**The National Football
Centre, St. George's
Park**

Preliminary Foul and
Surface Water Drainage
Strategy

Job title	The National Football Centre, St. George's Park	Job number	209289
Document title	Preliminary Foul and Surface Water Drainage Strategy	File reference	27
Document ref	209289/CIV/01

**PRE-DEVELOPMENT ENQUIRY CONCERNING FORTHCOMING PLANNING
APPLICATION CURRENTLY BEING PREPARED BY AECCOM**

Drawing Title
 Surface Water Drainage Strategy

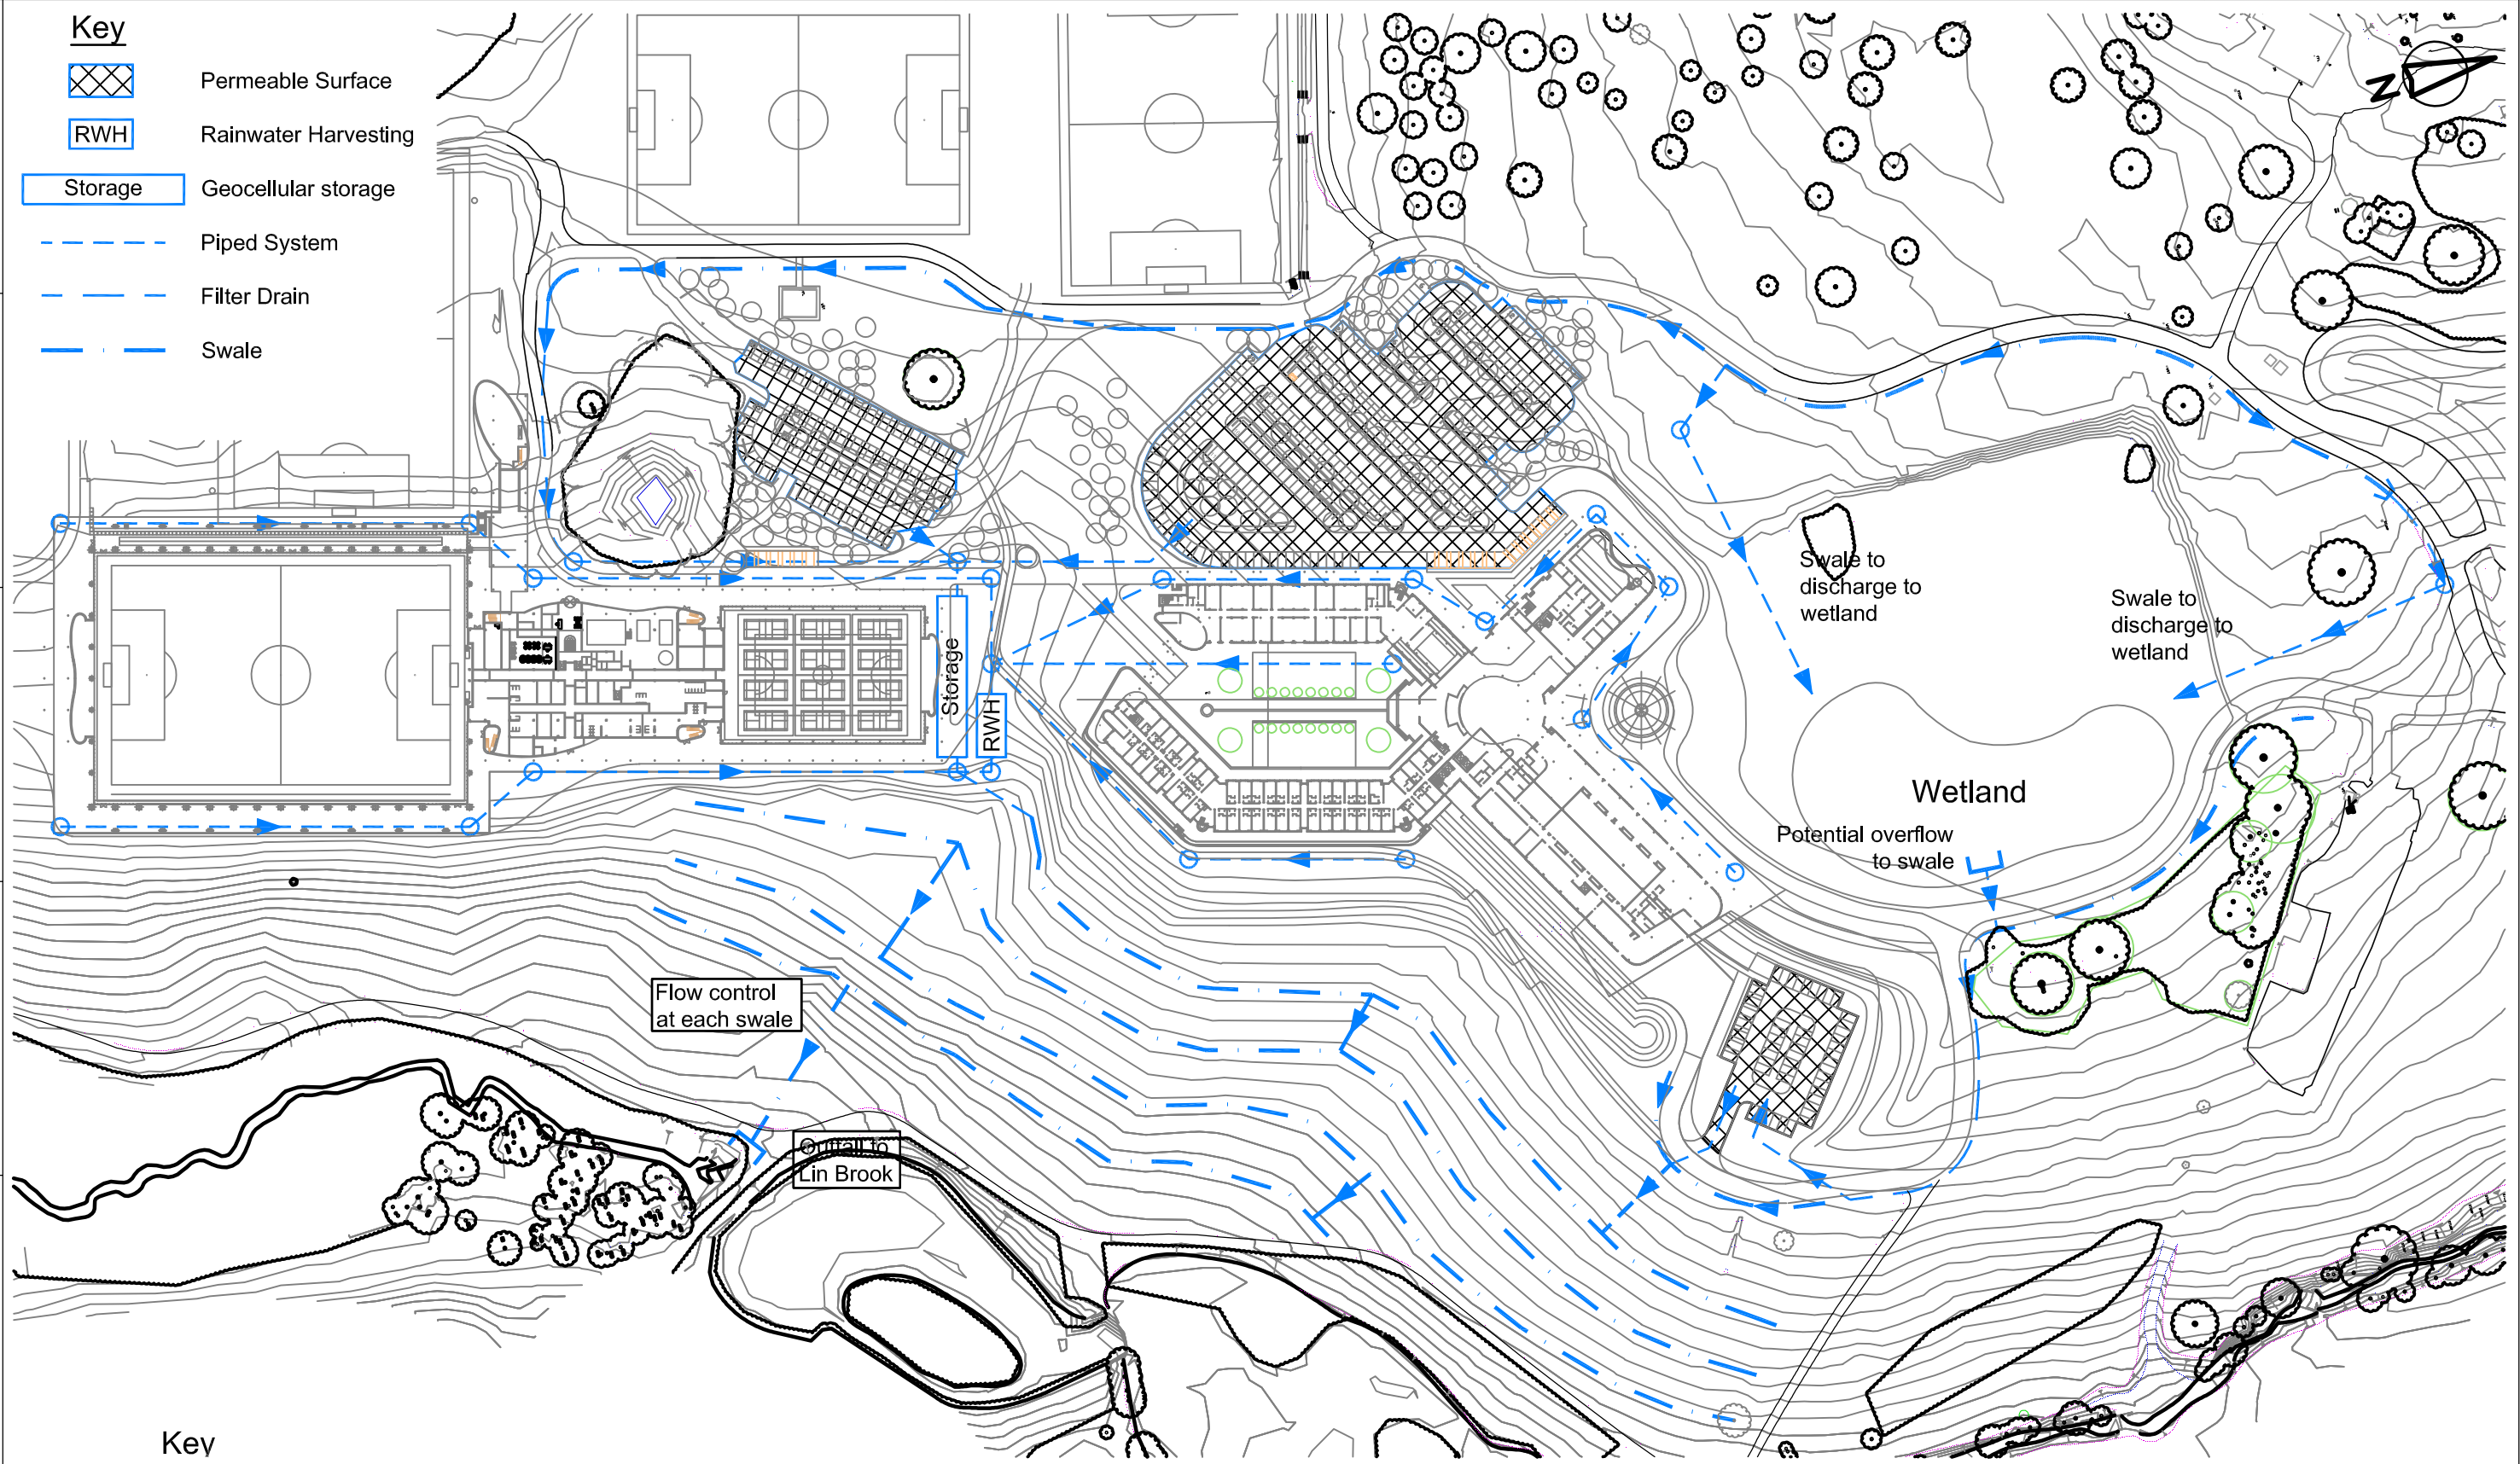
3. We acknowledge that some MicroDrainage Calculations have been submitted, however, the system must deal with the surface water run-off from the site up to the critical 1 in a 100-year return period storm event, plus an additional 30% to account for climate change. Drainage calculations must be included to demonstrate this (e.g. MicroDrainage or similar package calculations which include the necessary attenuation volume).

An assessment of the proposed drainage system should show that no above ground flooding occurs in a 30 year event, and that if flooding occurs in the 100 year event (plus climate change) that it remains on site and safe. If above ground flooding does occur in the 100 year event (plus climate change) it should be demonstrated that it remains on site & safe via plans, calculations (e.g. Microdrainage), manhole schedules and text. This information should show flow routes, locations of ponding, depths of ponding and durations of ponding. Evidence should also be submitted to show the determination of the critical storm duration.

The preliminary design for the surface water drainage system is indicated on drawing C.960.SK.001. Contributing impermeable areas and significant surface water storage features are indicated on drawing C.960.SK.003.

The current proposals include approximately 5070m³ of surface water storage for the critical 1 in 100 year storm, including an allowance of 30% increased peak rainfall intensity has been included within the design to account for potential climate change, split down as follows:

Drawing Title
Foul Water Drainage Strategy

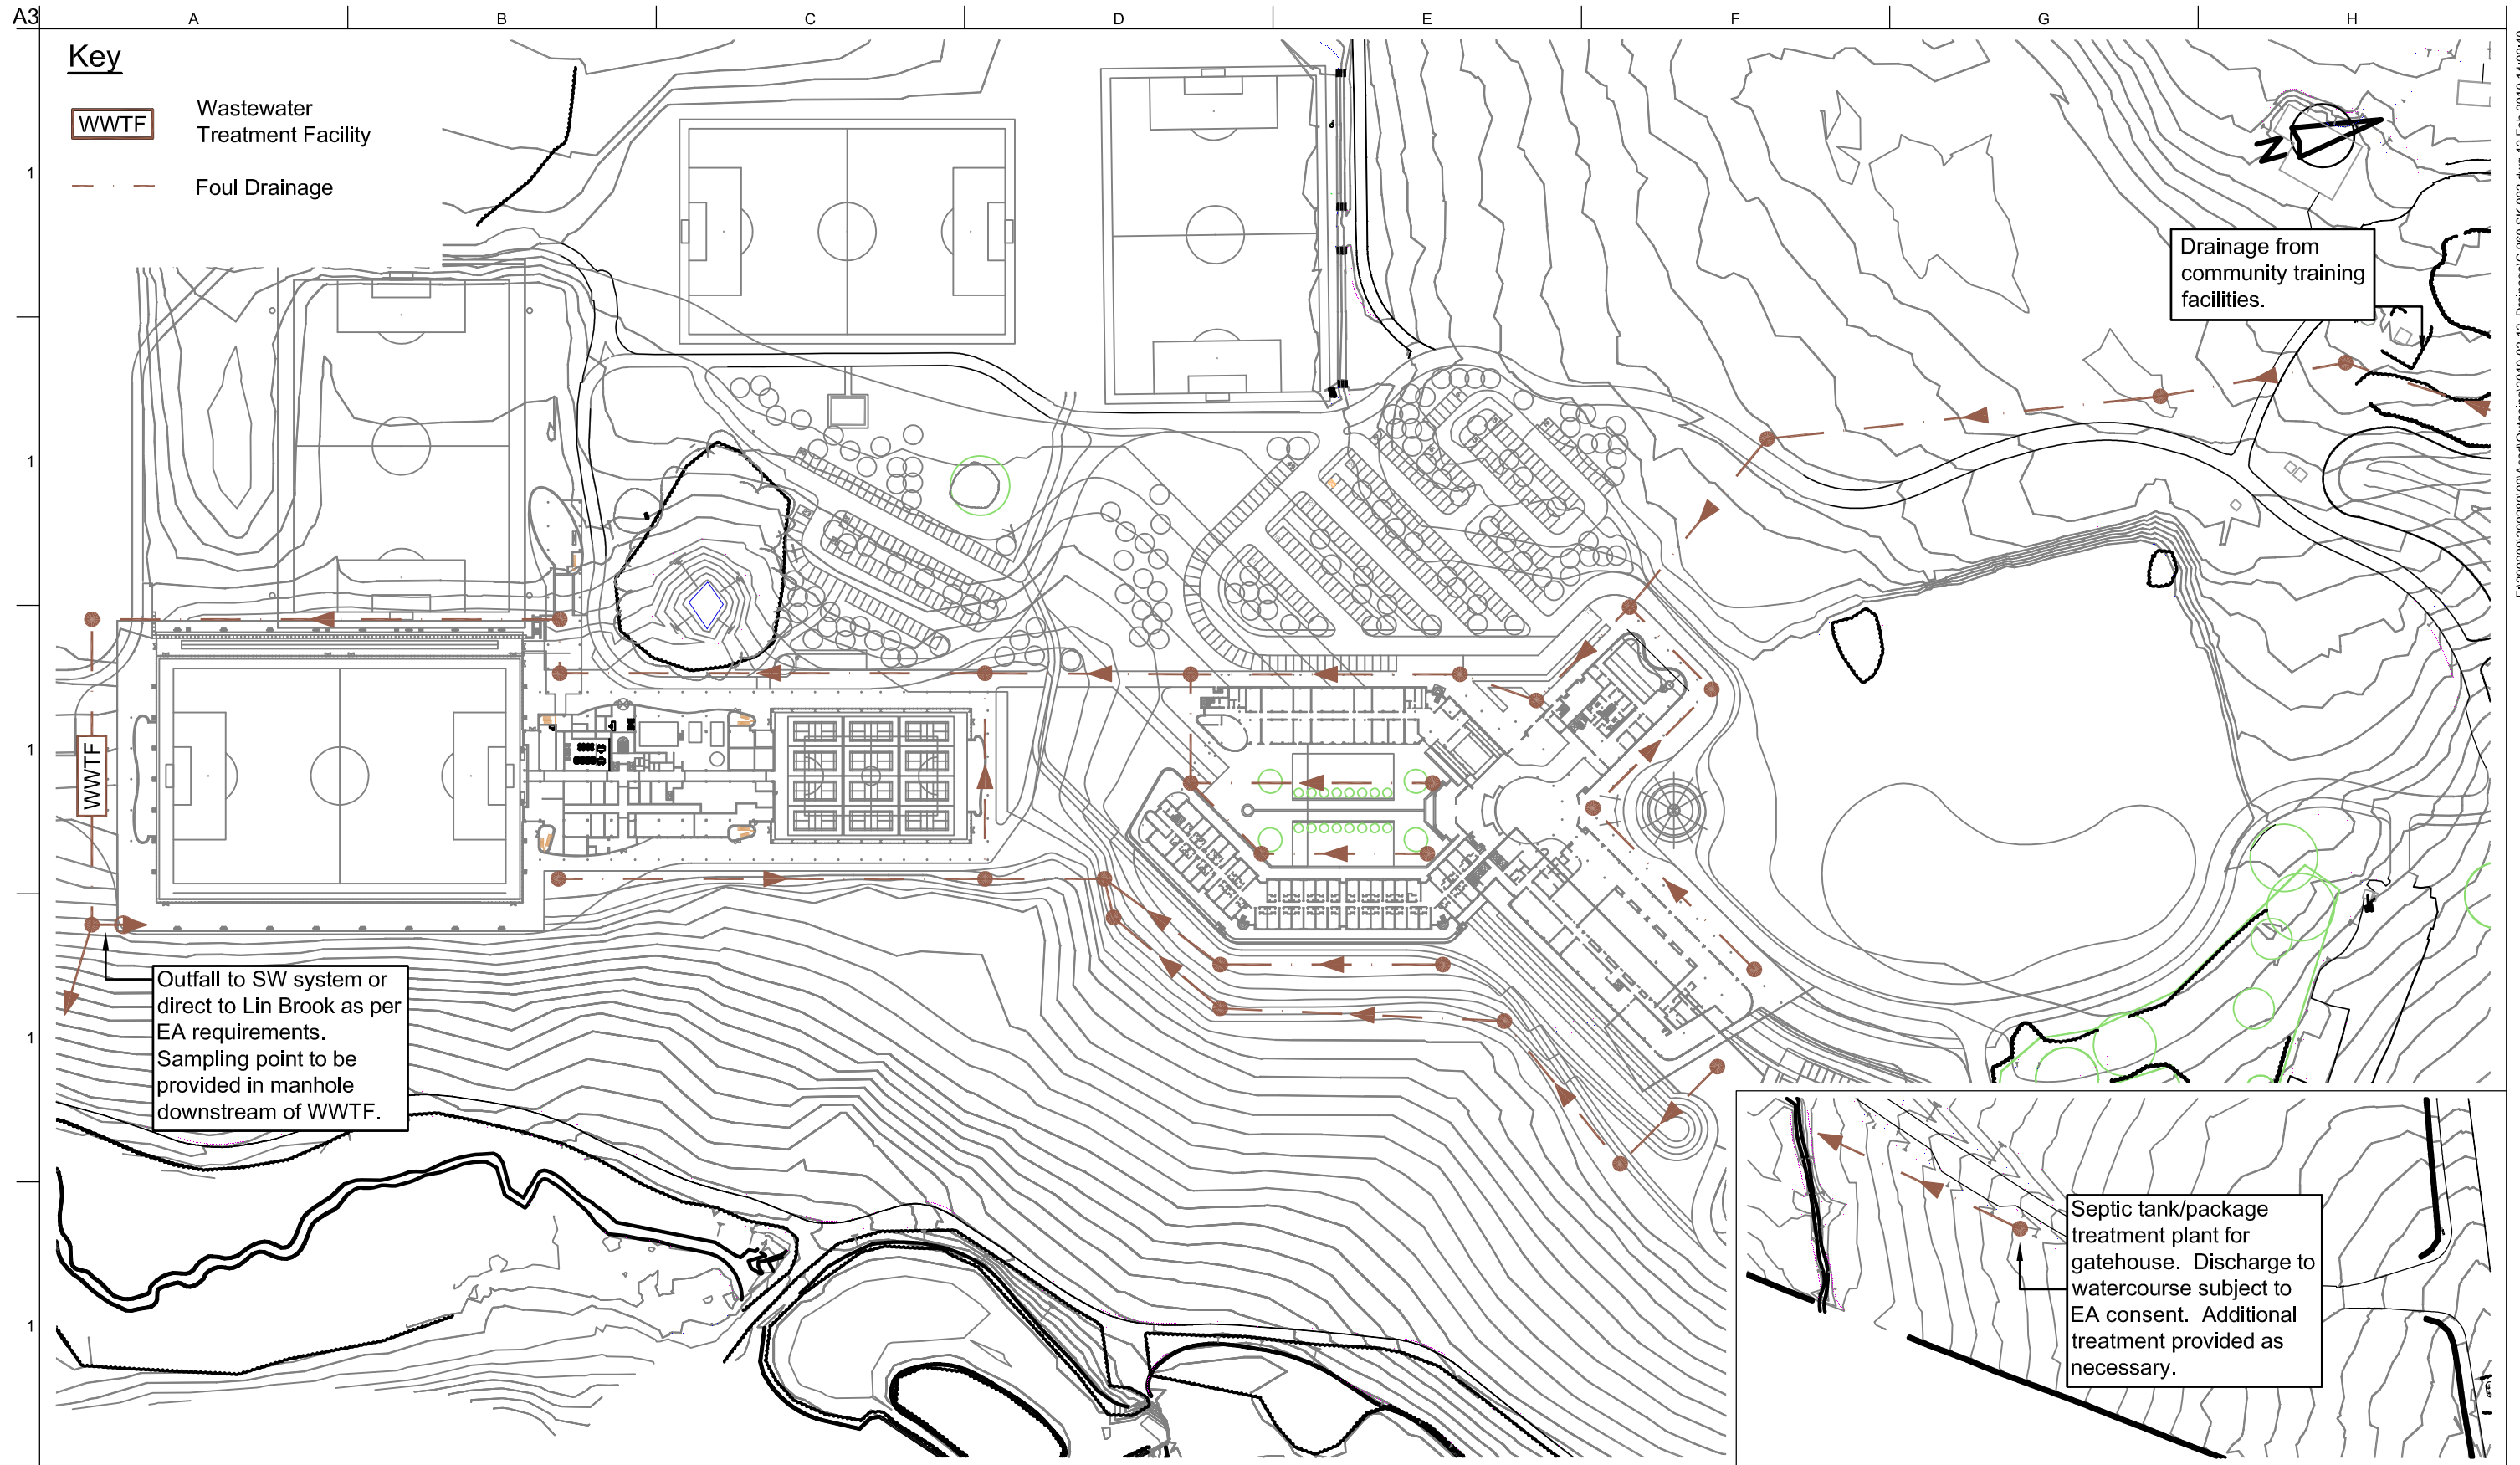
The effluent from the waste water treatment plant will require a consent to discharge whether it is mixed with surface water or discharged direct to the water course. An inspection/sampling chamber should be provided before the effluent is allowed to mix with any other discharge.

As such, and as with the previously submitted scheme, it is proposed that foul flows are conveyed to a wastewater treatment facility provided as part of the development. Treated effluent will be discharged to the Lin Brook, subject to the consent of the Environment Agency, either directly or via additional treatment as necessary.

Preliminary foul drainage proposals are indicated on drawing C.960.SK.002.
